SIB 61 23 20

2021-04-21

RECALL 20V-601: HIGH-VOLTAGE BATTERY RECALL

This Service Information Bulletin (Revision 9) replaces SI B61 23 20 **dated December 2020**.

SP44 HV Battery (G05) modules-

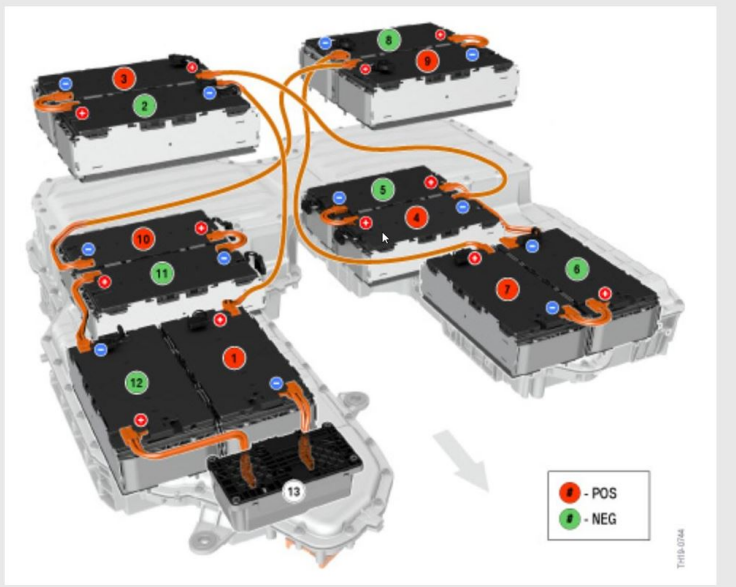
Modules are designed as Positive and Negative modules (with different orientation and part numbers). When replacing modules, verify in EPC the correct part (POS/NEG) and reinstall according to their original position. See below.

Use EPC diagram to verify the correct module part number (01/02) for NEG or POS modules.

Use the illustration on the right to match the part# with the correct module installation location.

- Module 12 is **NEG (01)**
- Module 1 is **POS (02)**
- Module 11 is **NEG (01)**
- Module 10 is **POS (02)**
- Module 2 is **NEG (01)**
- Module 3 is **POS (02)**
- Module 8 is **NEG (01)**
- Module 9 in **POS (02)**
- Module 5 is **NEG (01)**
- Module 4 is **POS (02)**
- Module 6 is **NEG (01)**
- Module 7 in **POS (02)**

SP41 HV Battery (G01/G20/G20/G12) modules-

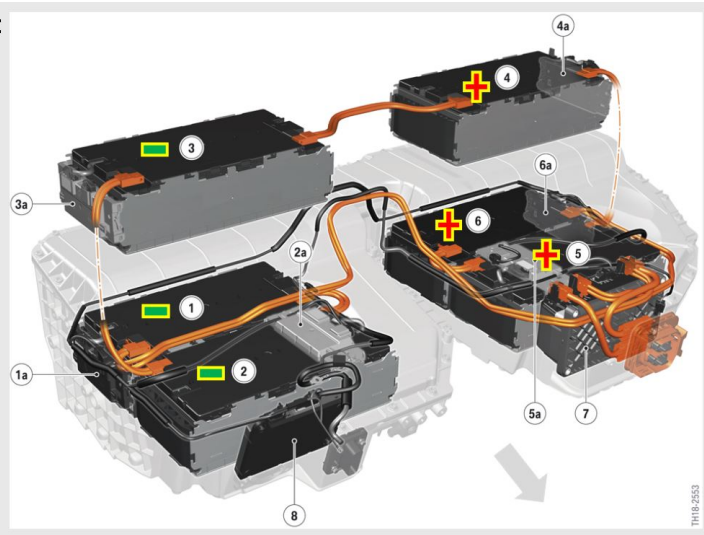
Use EPC diagram to verify the correct module part number (01/02) for NEG or POS modules.

Use the illustration on the right to match the part# with the correct module installation location.

- Module 1 is **NEG (01)**
- Module 2 is **NEG (01)**
- Module 3 is **NEG (01)**
- Module 4 is **POS (02)**
- Module 5 is **POS (02)**
- Module 6 is **POS (02)**
